SERVICE BULLETIN – 01/MARCH 2005

SP 405 - SP 605- SPN 1205

NEW GEAR REDUCER PLASTIC DRIP TRAY

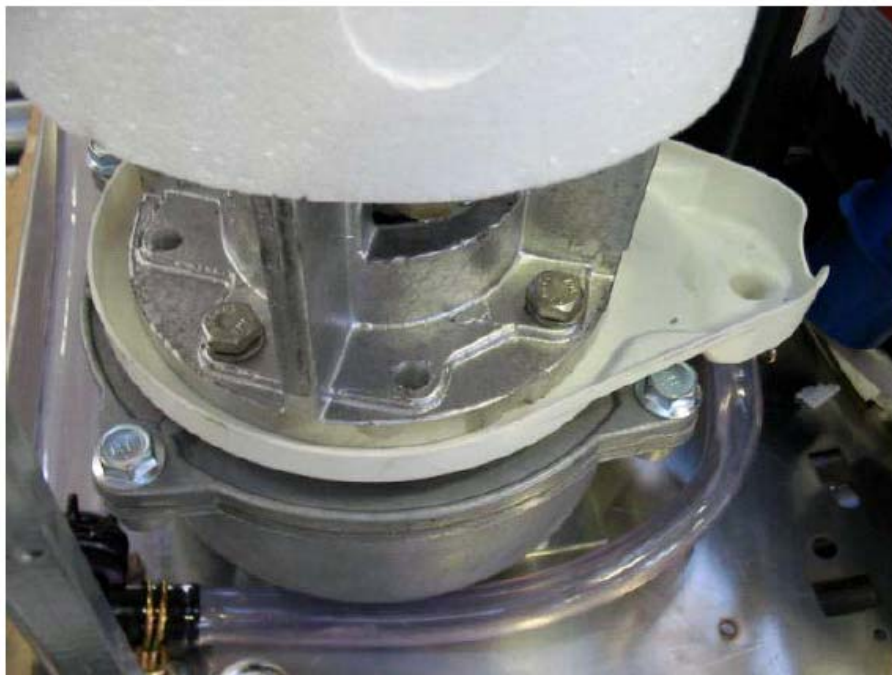
The previous gear reducer metal drip tray Part Number 650686 00 has been replaced with a **new** plastic one of different shape and equipped with an overflow located below the output shaft oil seal level, as detailed on the bottom photo.

The **new** plastic drip tray is available under **Part Number 660755 00** and it is exchangeable with former one with partial modification of the plastic drain hose.

The new plastic drip tray will be supplied in place of former one as soon as we'll run out of stock.
